Addendum 01

Project: CSV L'Harmonie Child Care Addition **Date:** 07 November 2024
158 Bridgeport St E, Waterloo, ON **Pages incl. cover:** 16
Tender No.: 25-28

Architect:	Workshop	Date:	November 6, 2024
Project:	CSV L'Harmonie Daycare Addition	Project No.:	22-058

.1 C2.0 Site Demolition Plan

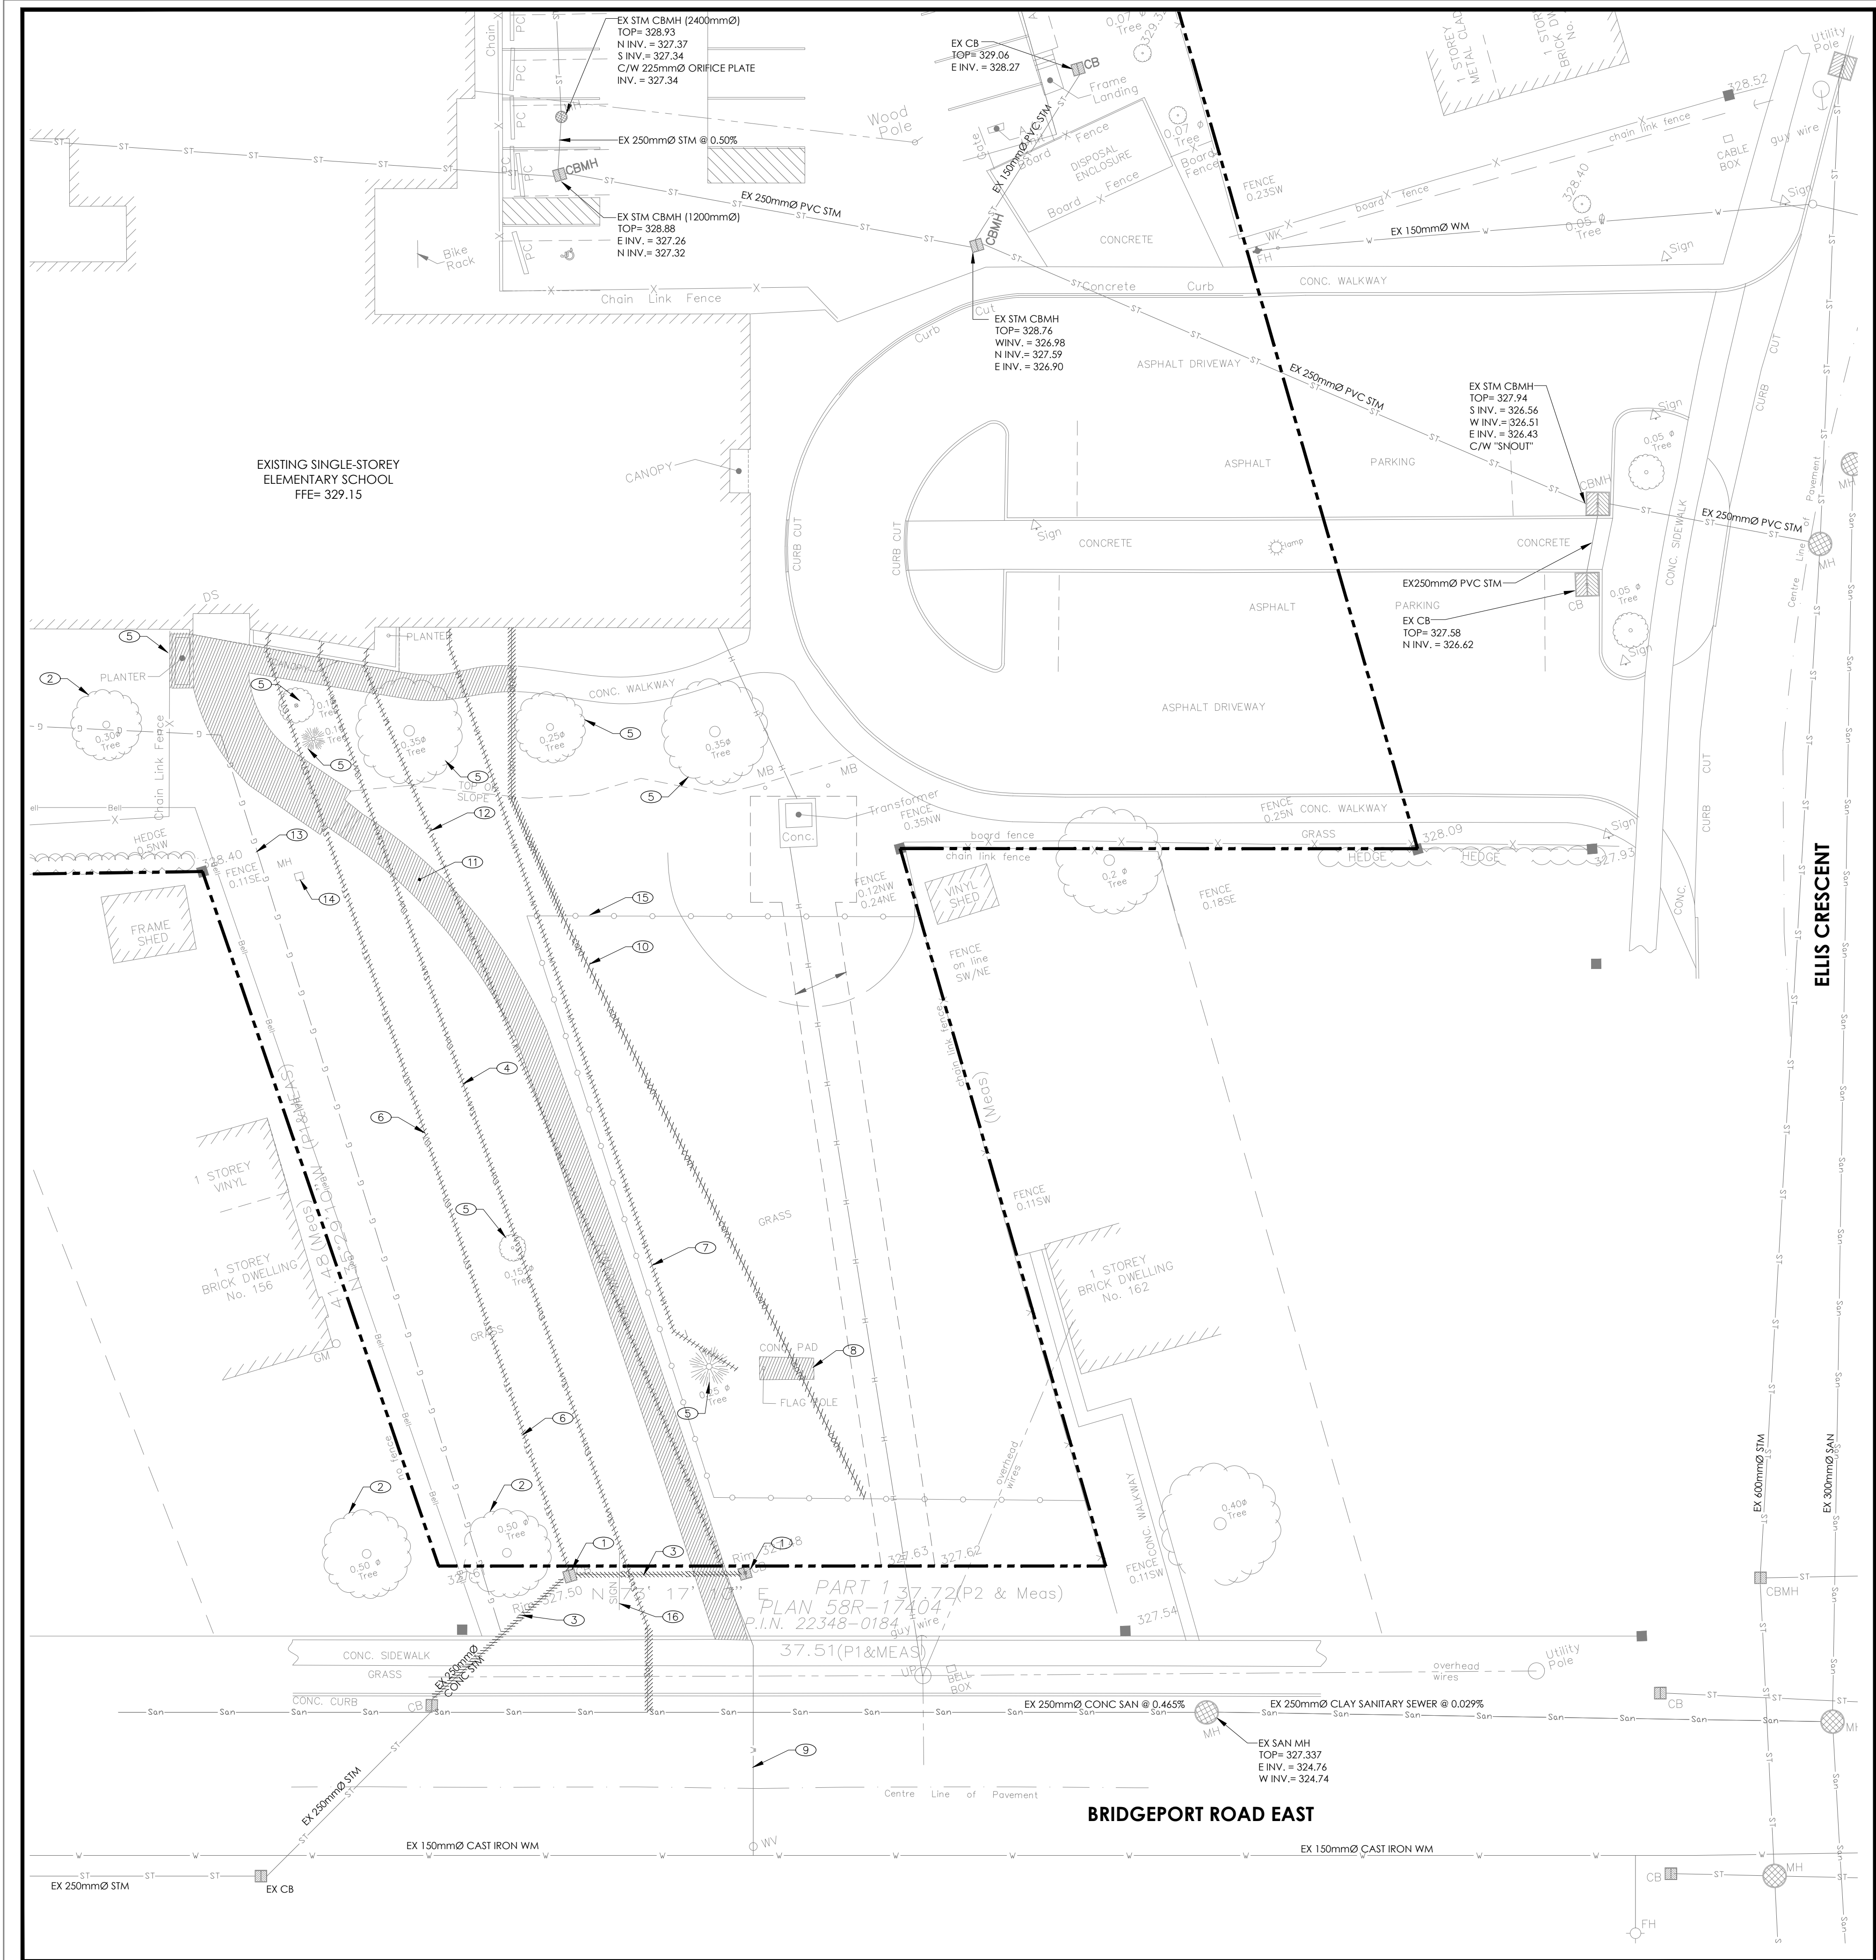
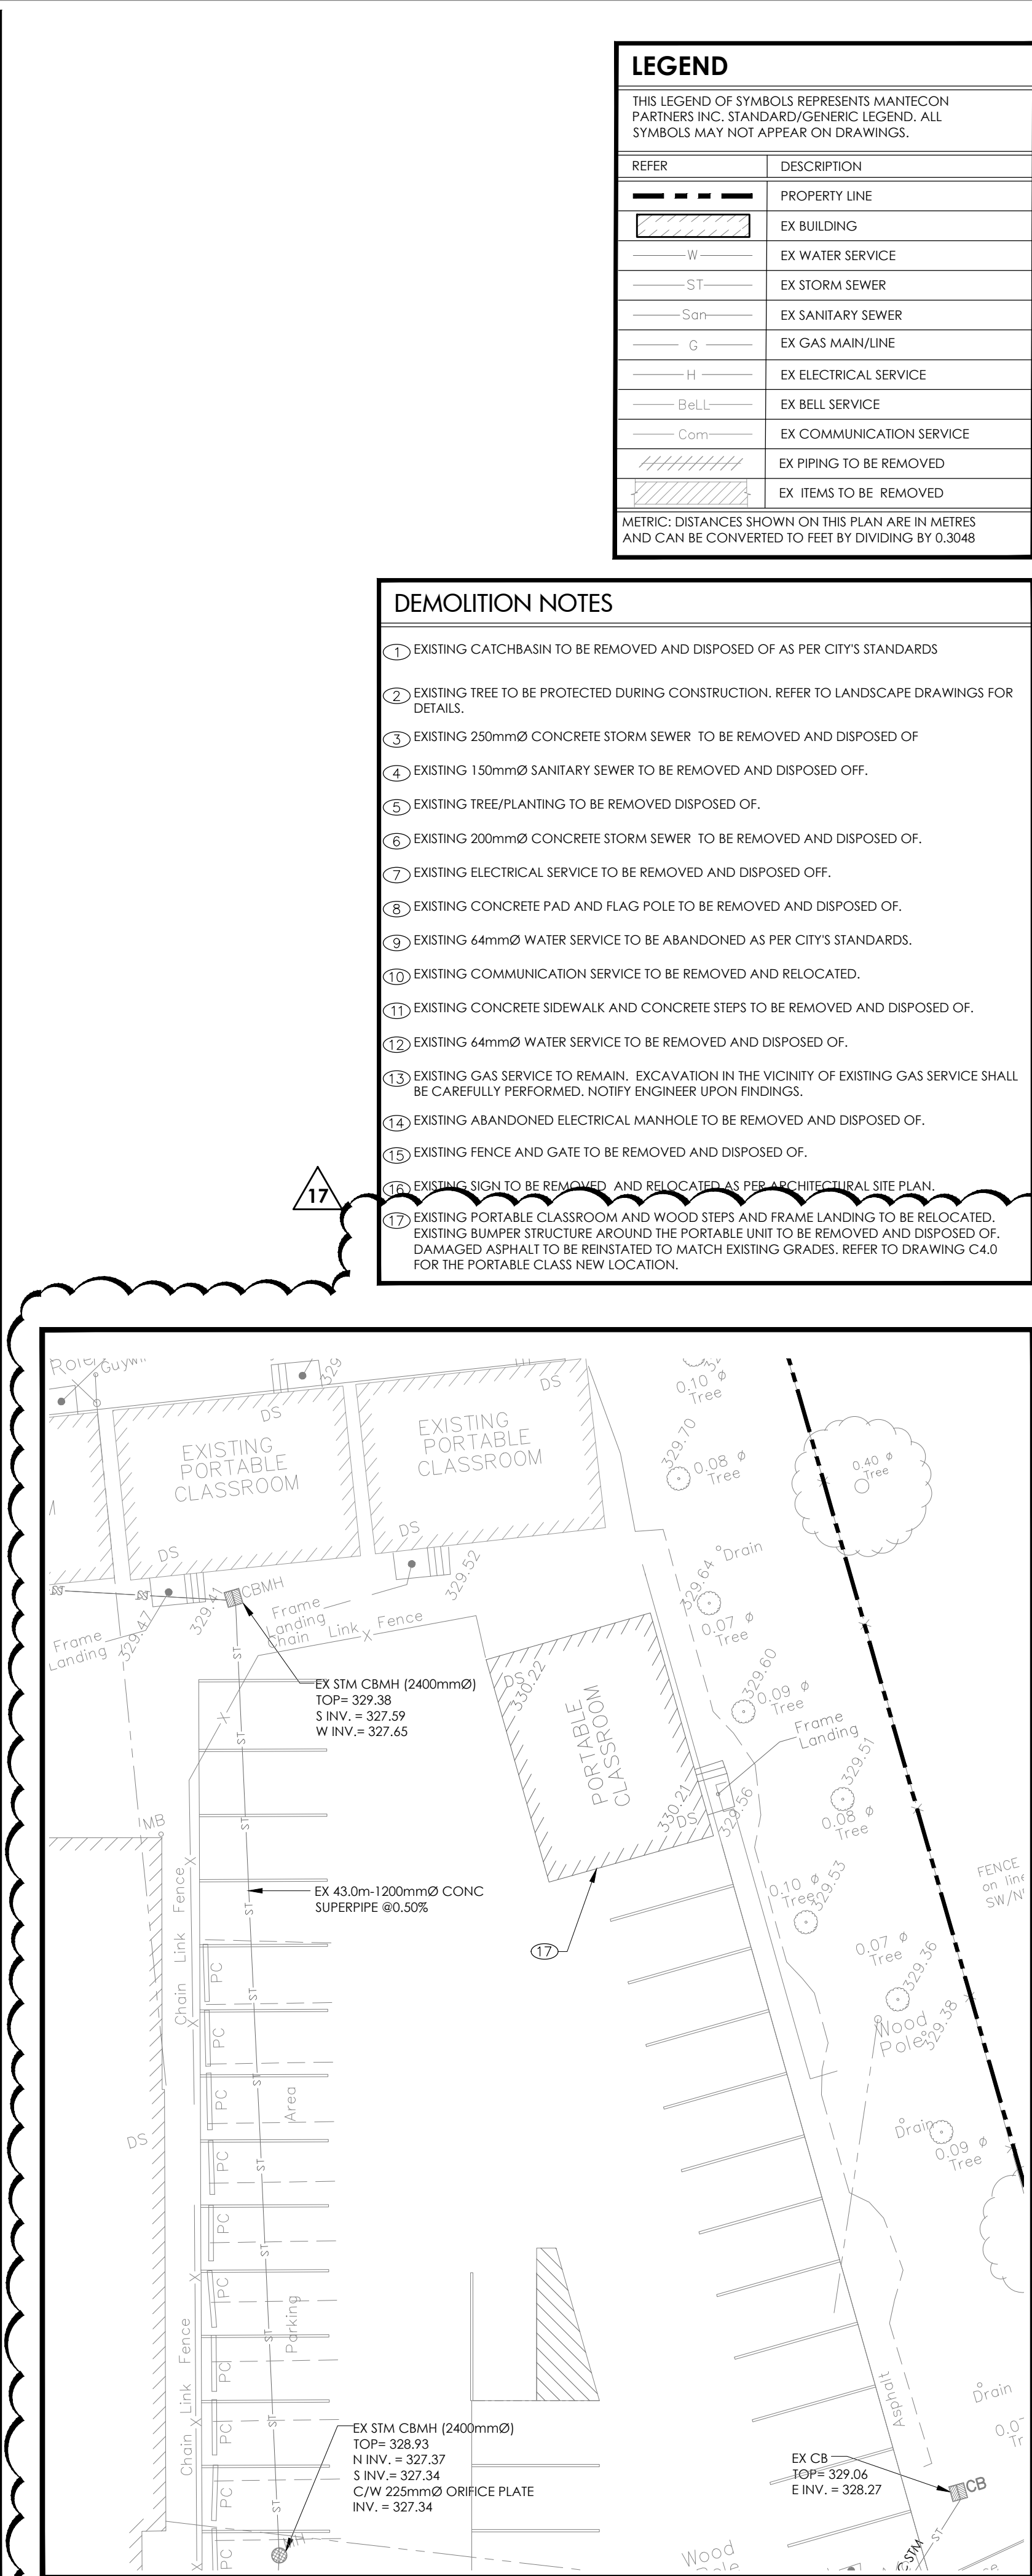
- Remove and relocate existing portable classroom, wood steps and frame landing.
- Remove and dispose of existing bumper structure around the portable unit that is being relocated.
- Reinstall damaged asphalt due to relocating the portable unit. Grades to match existing.

2 Site Plan
1 : 1200

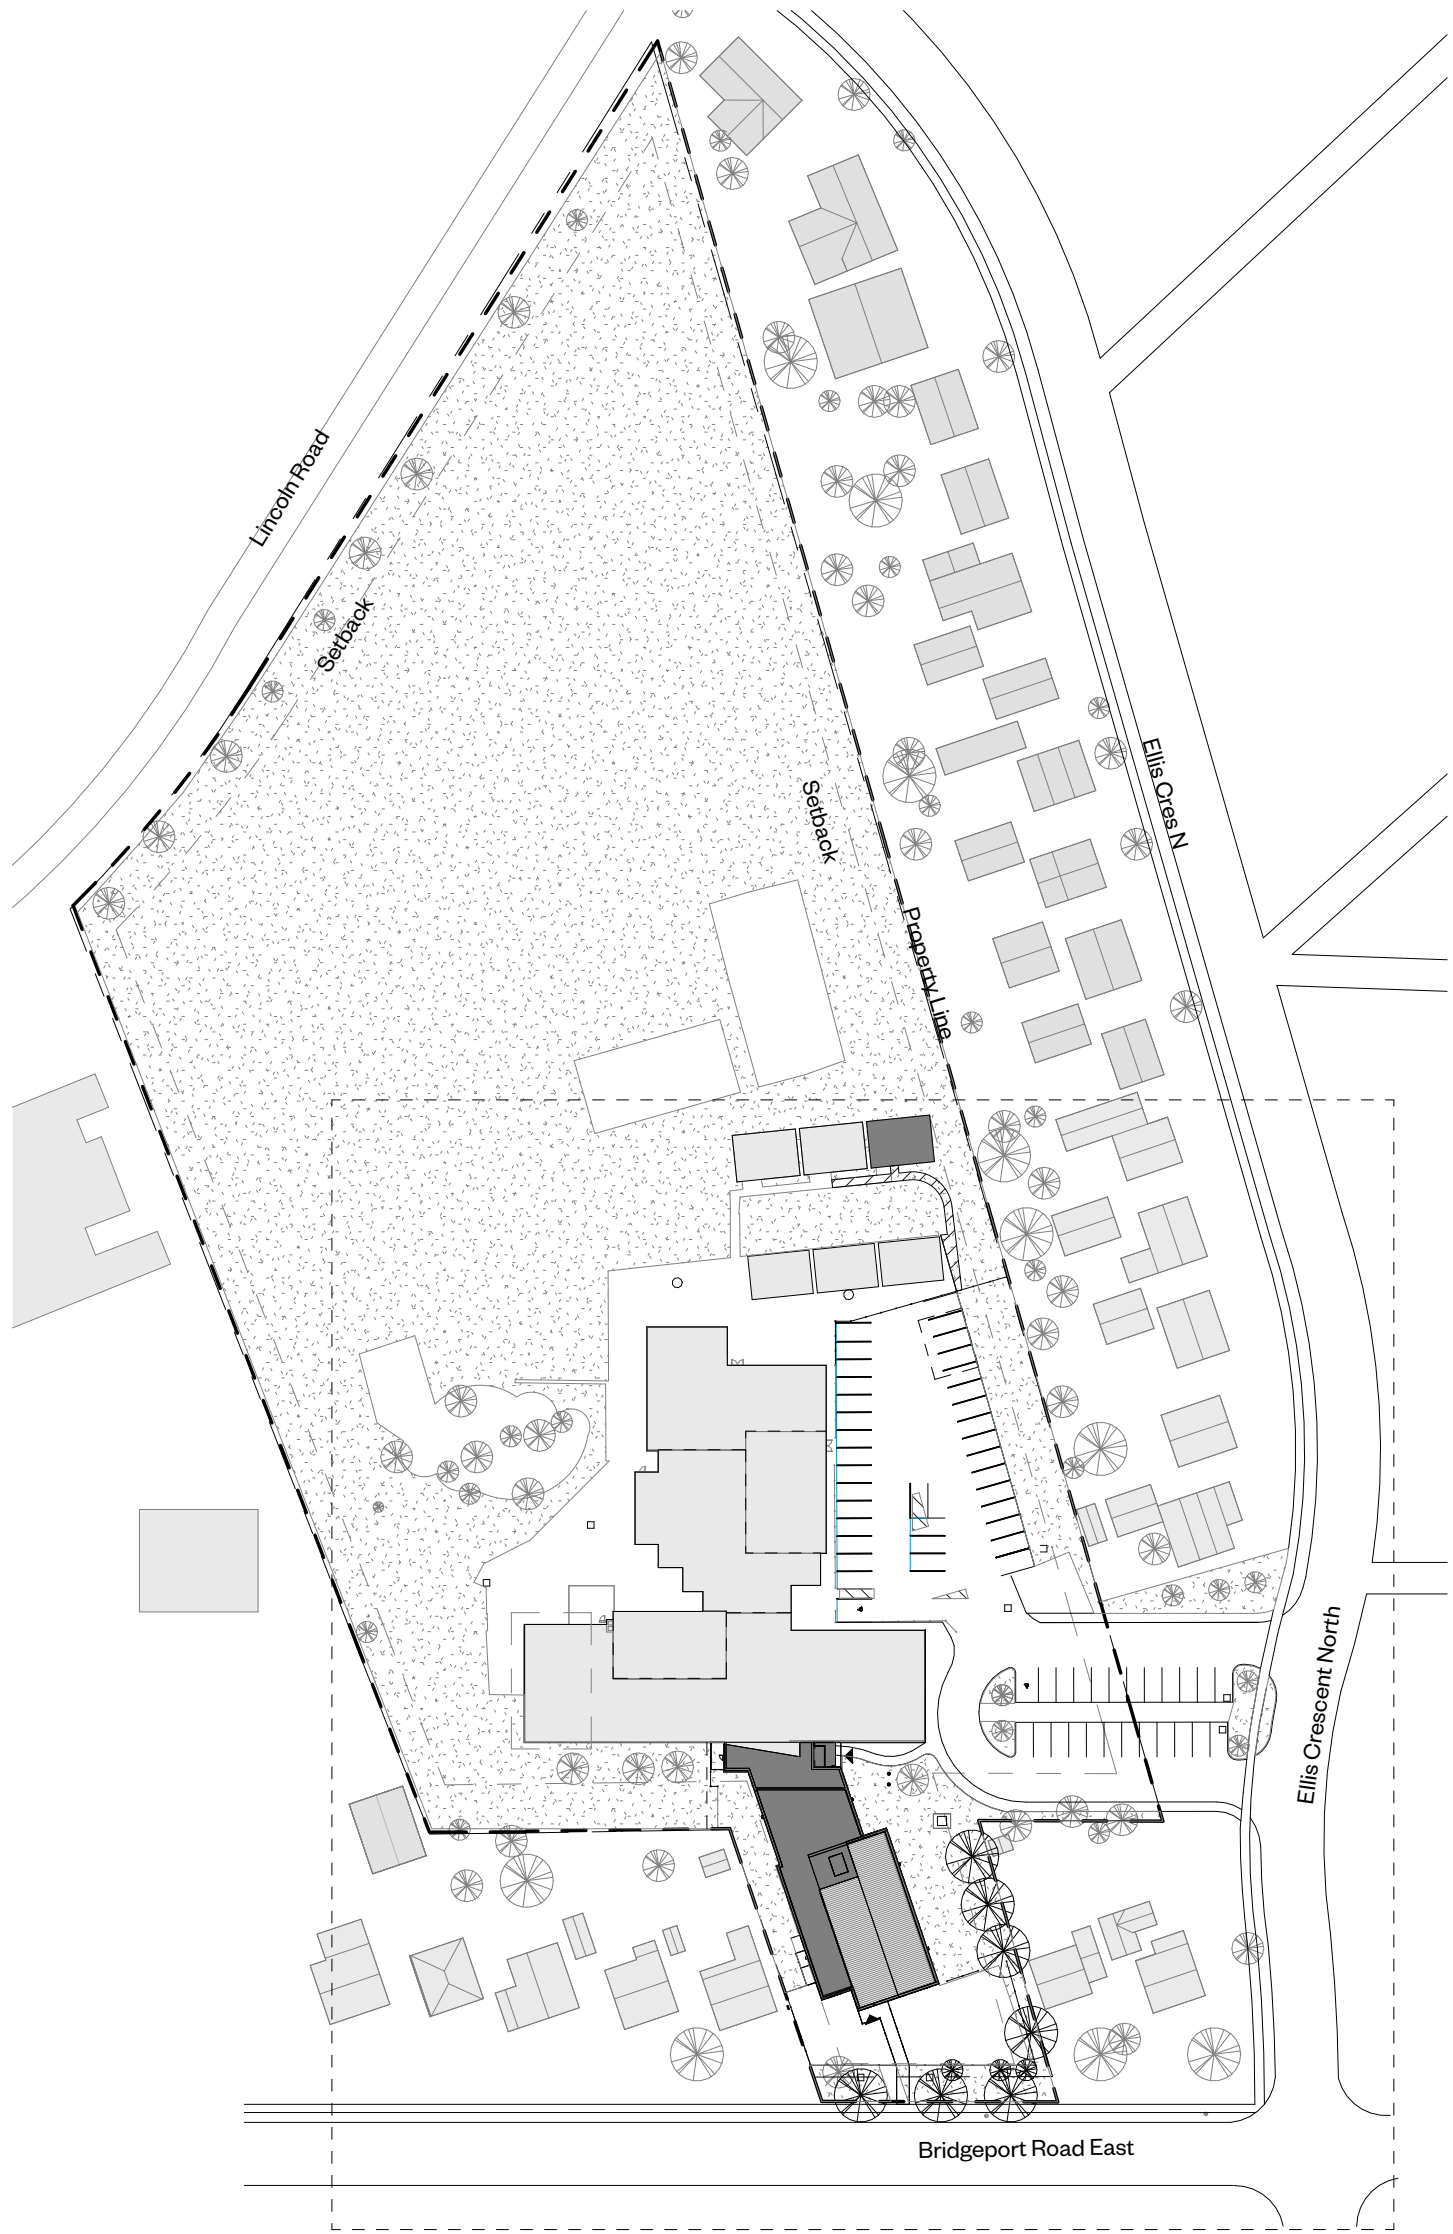
1.03	Clarification: The 1.8m wood fence has been added to the architectural site plan 1/A1.0 to match Landscape drawings.
1.04	Clarification: Details of the RTU screen have been deleted from sheet A3.0. Metal RTU screen has been deleted.
